Marin County Flood Control and Water
Conservation District
**Corte Madera Creek Flood Risk Management
Project, Phase 1**
Final Environmental Impact Report
Volume 1: Comments and Responses to Comments
State Clearinghouse No. 2020080353

**Marin County Flood Control and Water
Conservation District
Corte Madera Creek Flood Risk Management
Project, Phase 1
Final Environmental Impact Report
Volume 1: Comments and Responses to Comments
State Clearinghouse No. 2020080353**

Figure 2-5 Alternative 1 Change in Water Surface Elevation from Existing Conditions , 100-Year Flood Event (Upper Corte Madera Creek)

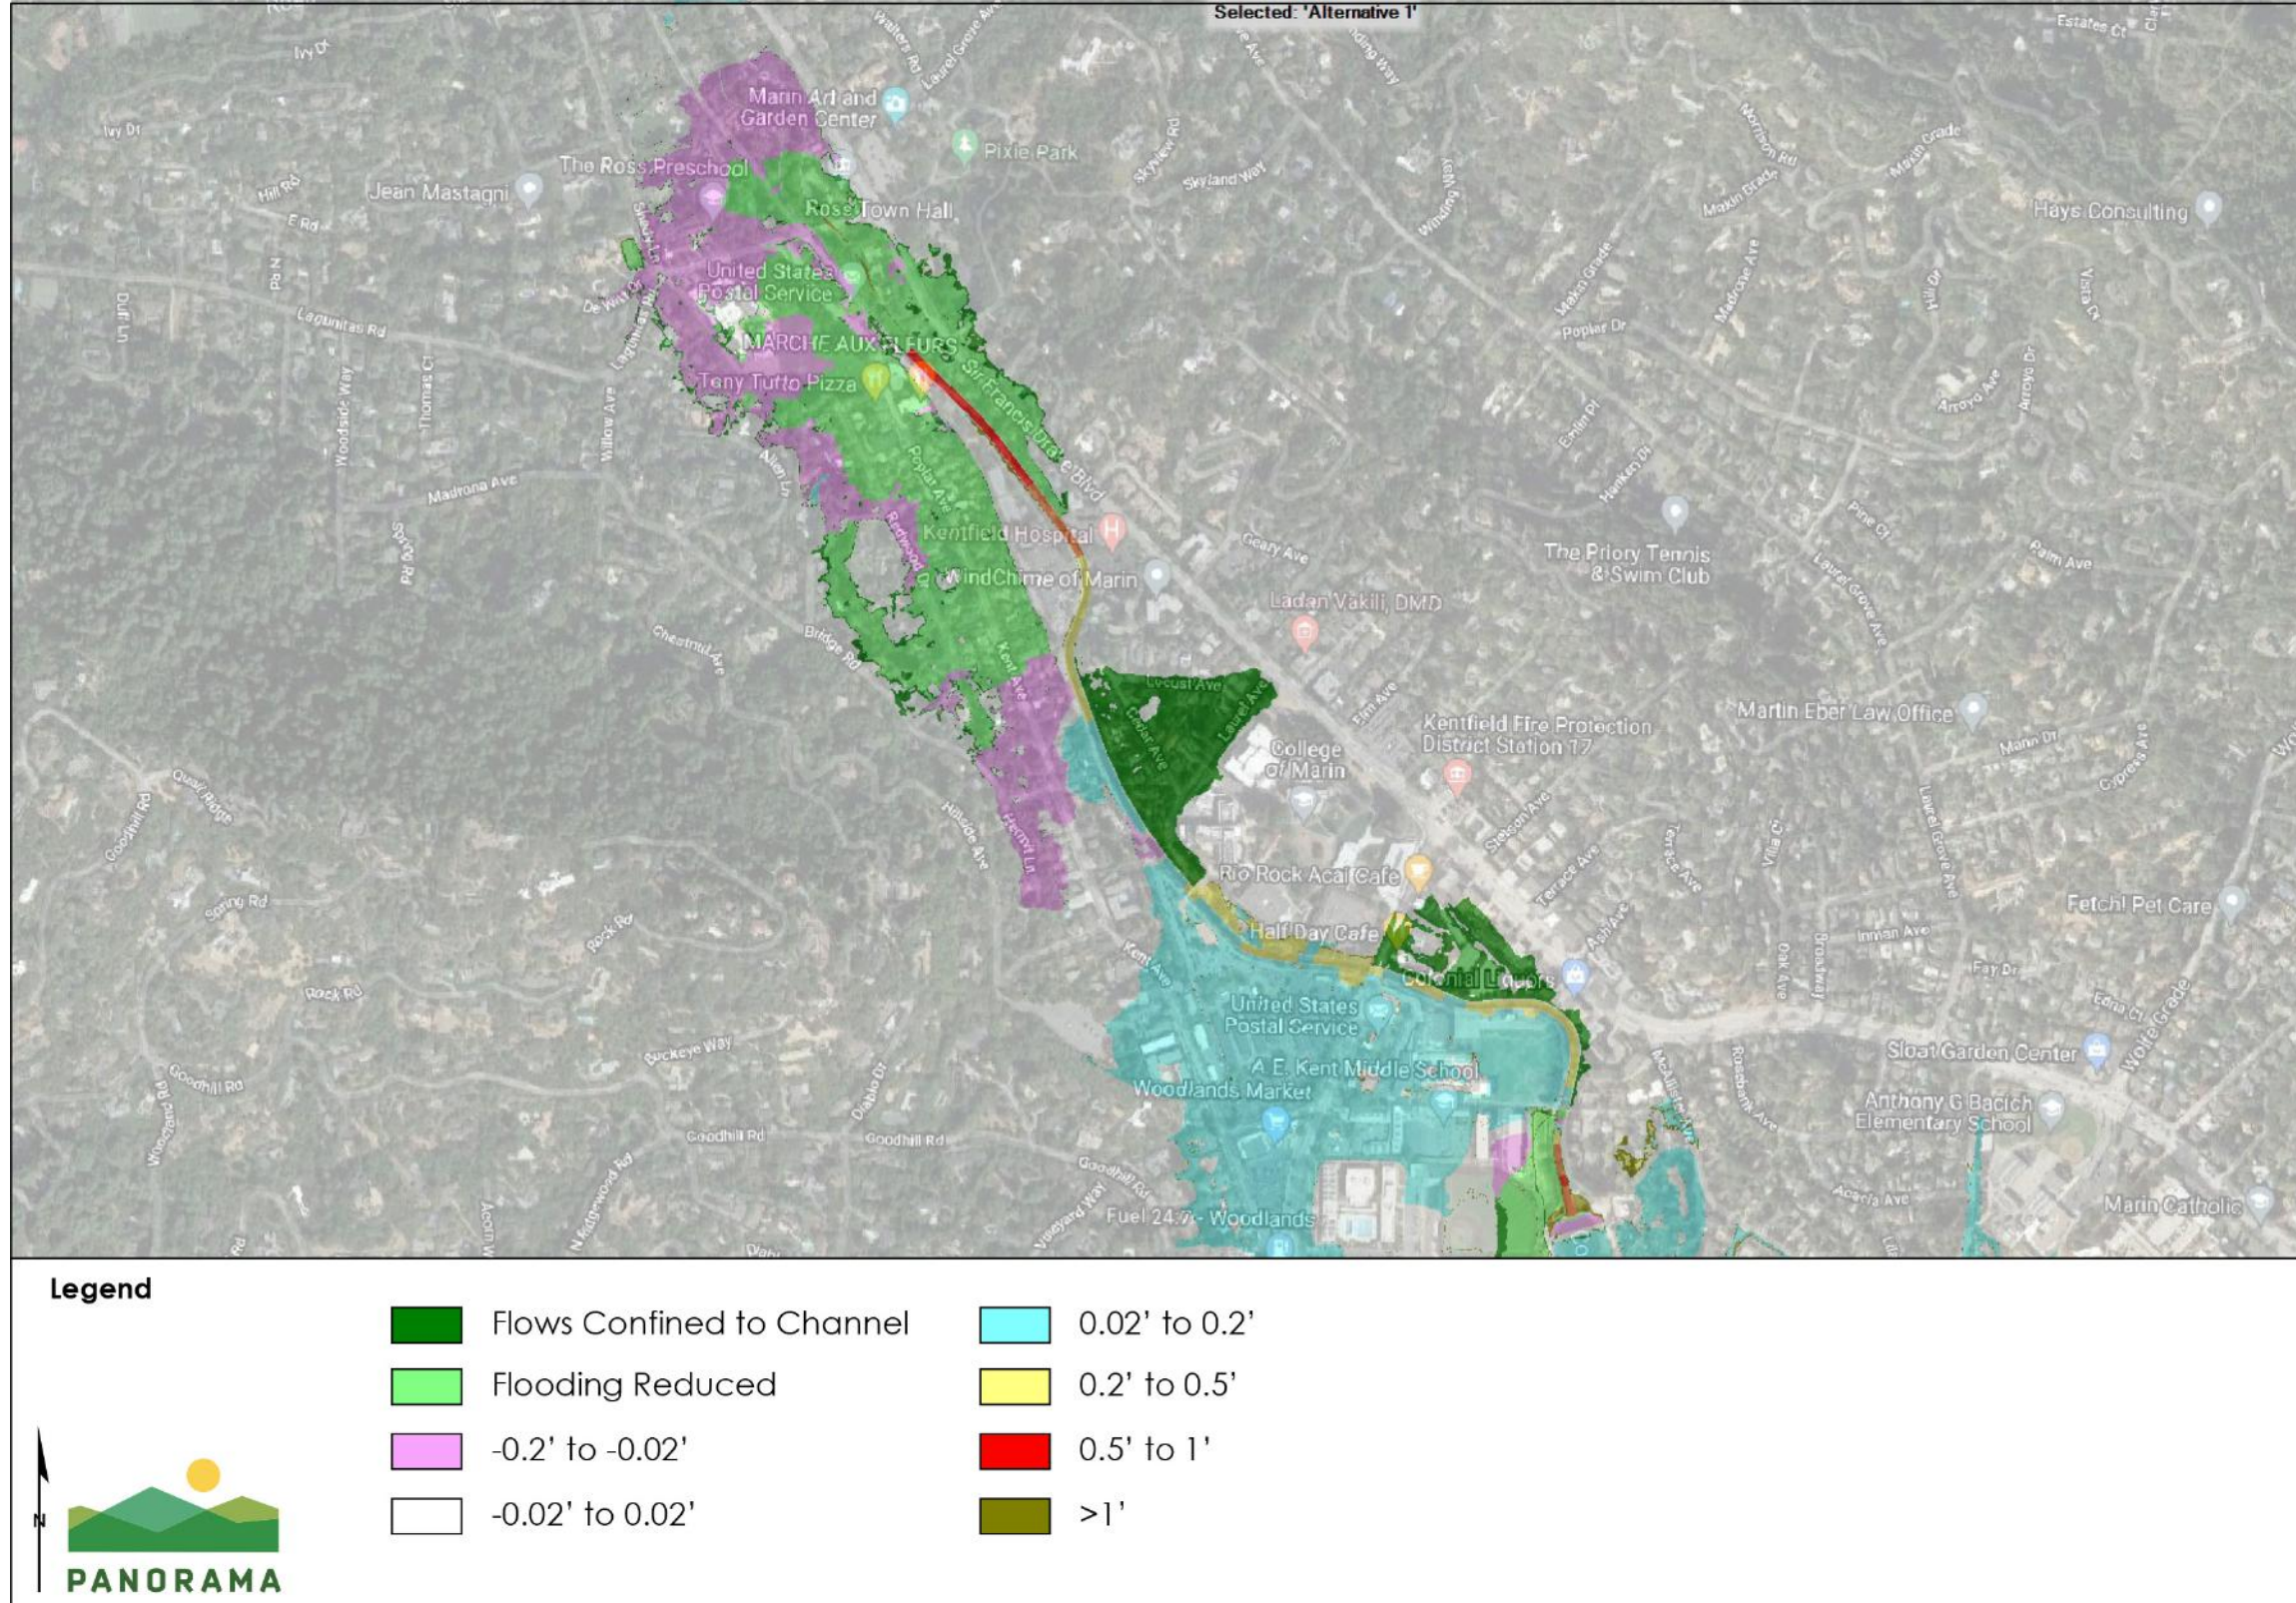
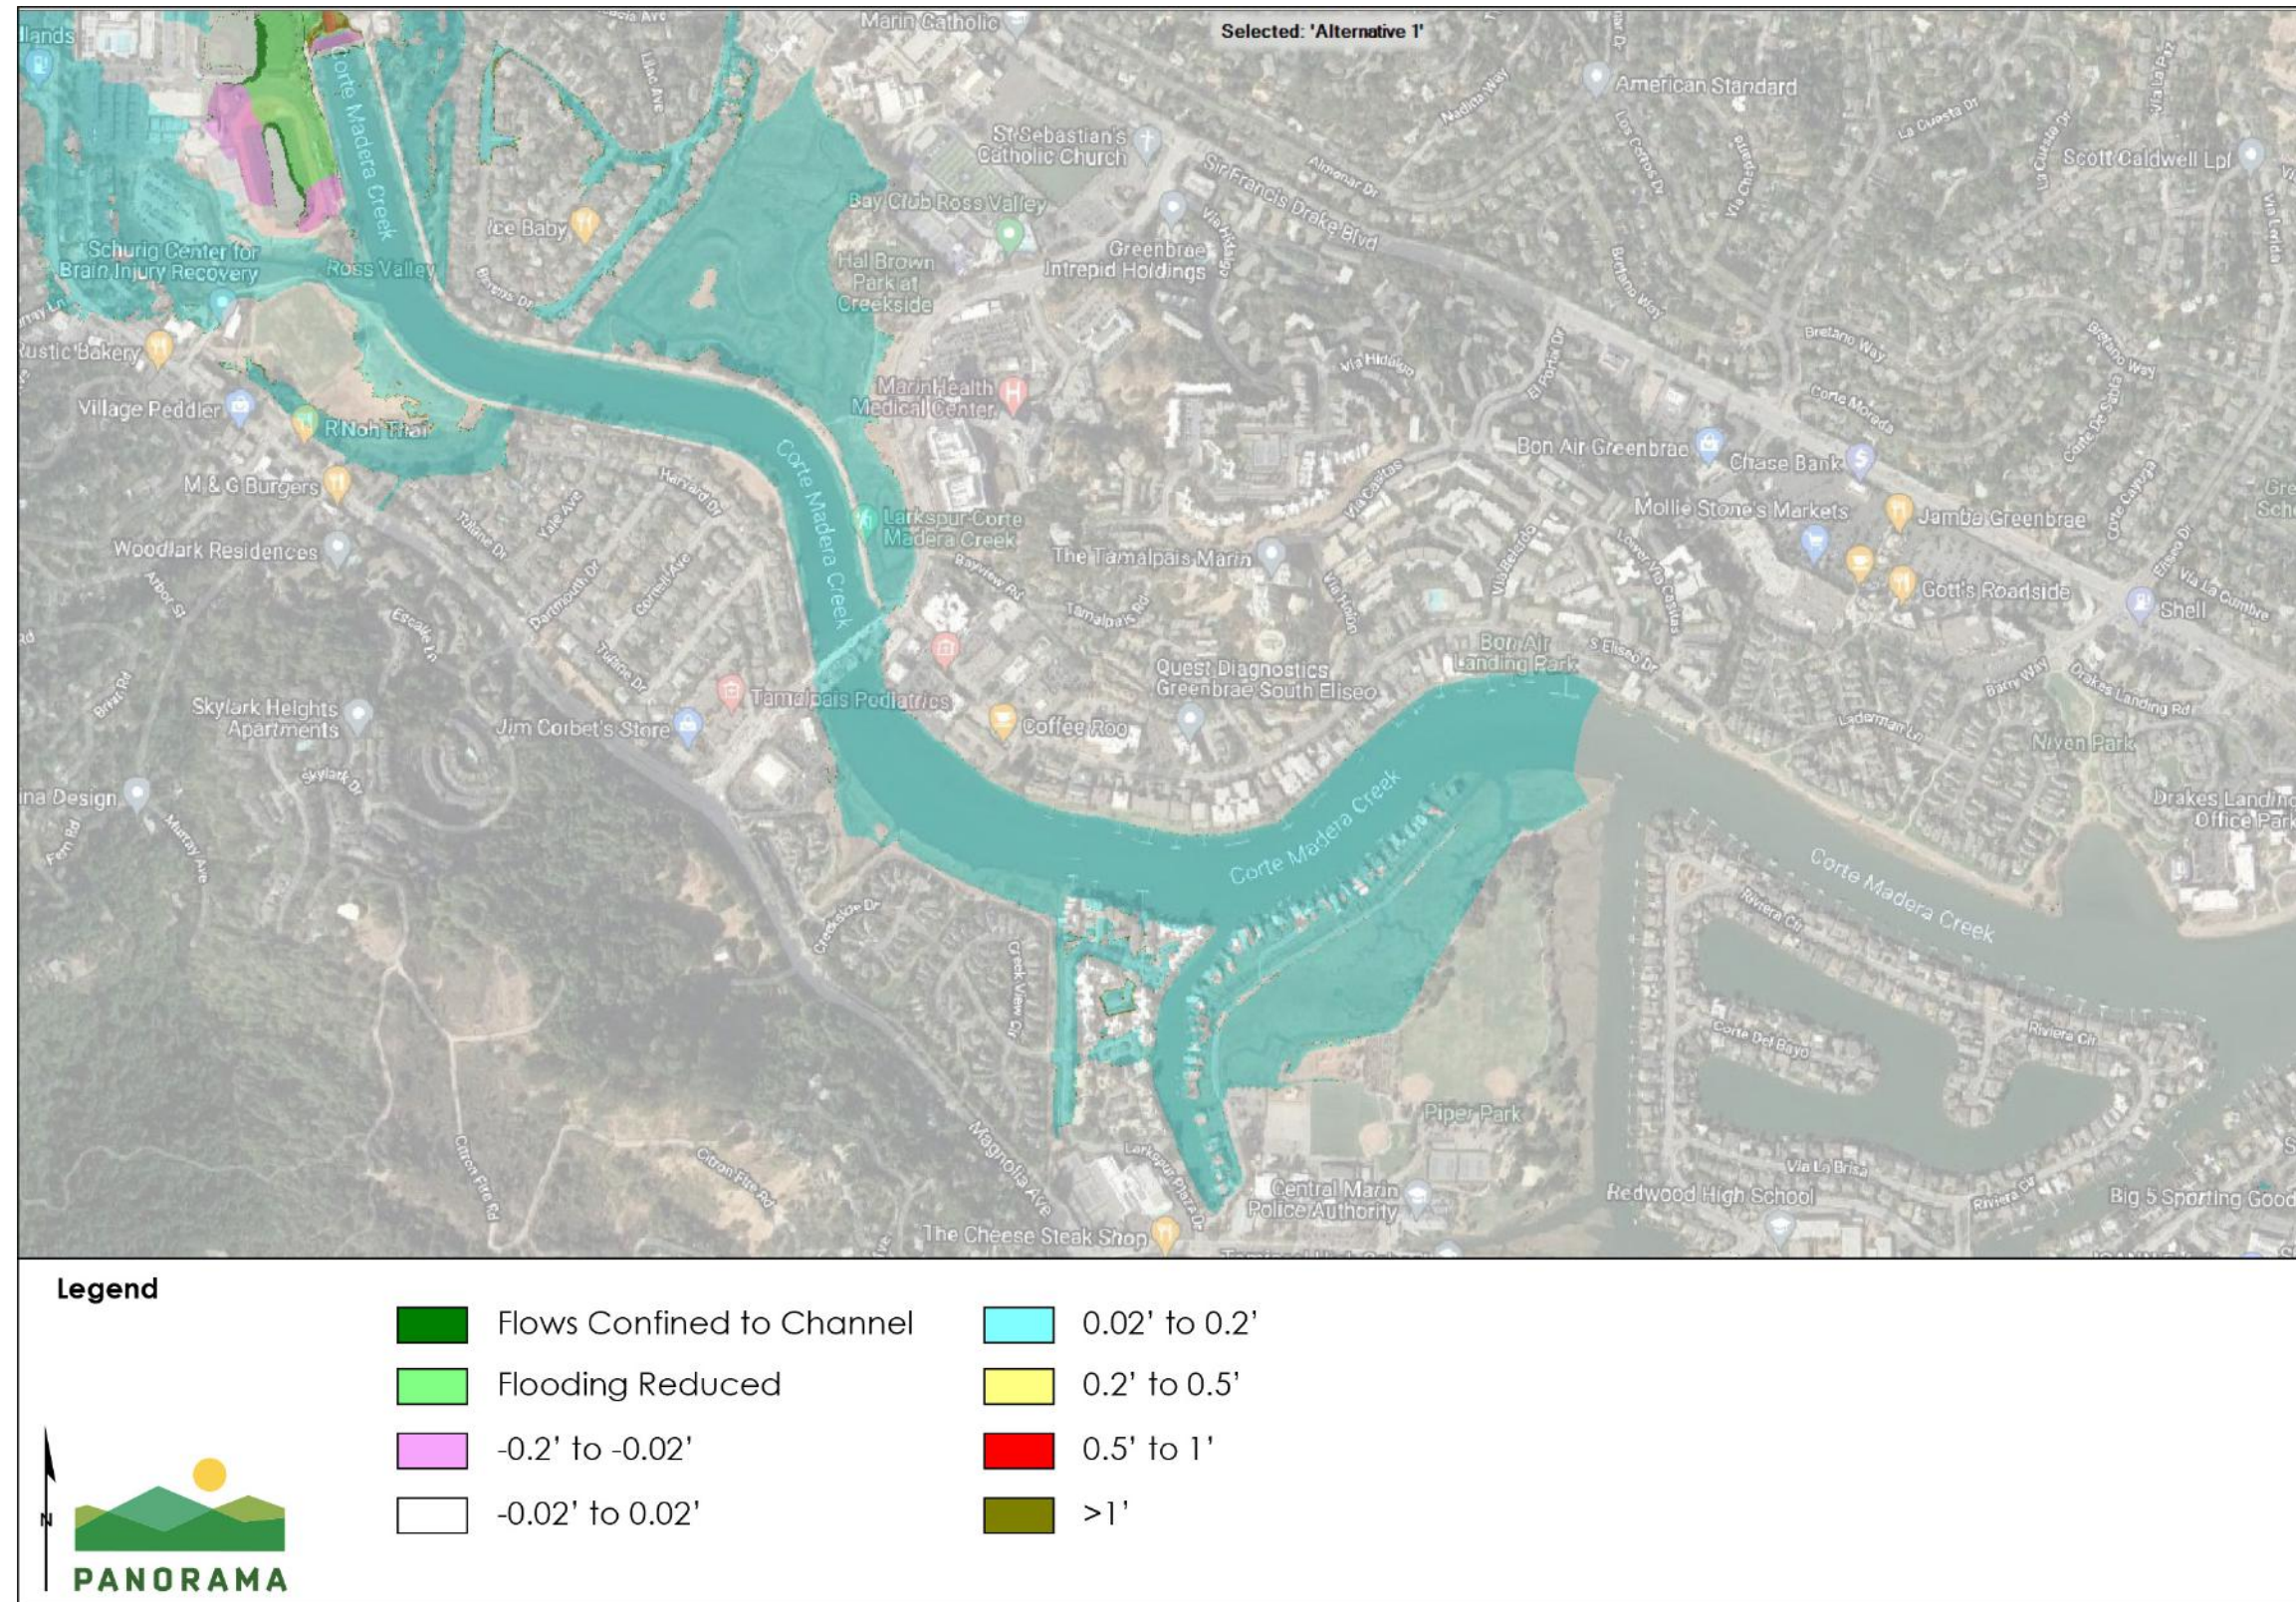
The geographic extent of the figures showing the changes in WSE differs from the figures included in the Draft EIR. The geographic extent of the figures was expanded to show areas downstream from Unit 2 in response to comments from the City of Larkspur. As discussed on page 3.9-39 in the Draft EIR, a threshold of 0.2 foot (2.4 inches) was used for determining whether a potentially significant increase or decrease in WSE would occur at any structure. The 0.2-foot threshold is a reasonable level of precision for evaluating flooding impacts, considering the standards for accuracy and precision associated with hydraulic modeling.

Figure 2-1 through Figure 2-6 show the Alternative 1 changes to the WSE and reflect the difference in WSE between the Existing Condition Without Project and Existing Condition With Alternative 1 scenarios under a 10-, 25-, and 100-year flood, using the updated modeling for the 60 percent design. Figure 2-7 through Figure 2-12 show the Alternative 1 changes to the WSE under for the future condition scenario, and reflect the difference in WSE between the Future Condition Without Project and Future Condition With Alternative 1 under the 10-, 25-, and 100-year flood conditions. The assumptions used in the future condition modeling are described on pages 3.9-35 through 3.9-37 in Section 3.9 in the Draft EIR and are supplemented by the model updates described above. Figure 2-13 through Figure 2-18 show the Alternative 1 changes to the WSE under a “high-emissions likely” sea-level rise scenario, to reflect 2100 projected sea-level rise based on the 2018 Update of the State of California Sea-Level Rise Guidance (California Ocean Protection Council, 2018). Figures 2-13 through 2-18 reflect the difference in WSE between the Year 2100 Future Condition Without Project and Year 2100 Future Condition with Alternative 1 scenarios under the 10-,25-, and 100-year flood conditions.

Areas shown in the figures as “Flows Confined to Channel” are areas that are currently flooded by Corte Madera Creek, which are predicted to no longer have flood inundation from Corte Madera Creek overtopping after Alternative 1 is implemented. Areas shown in the figures with “Flooding Reduced” are areas with reduced flood inundation (greater than 0.2 foot) from creek overtopping after Alternative 1 is implemented. The change in WSE shown on the maps reflects a comparison between WSE without implementation of Alternative 1 and the WSE after implementation of Alternative 1 for each modeled scenario.
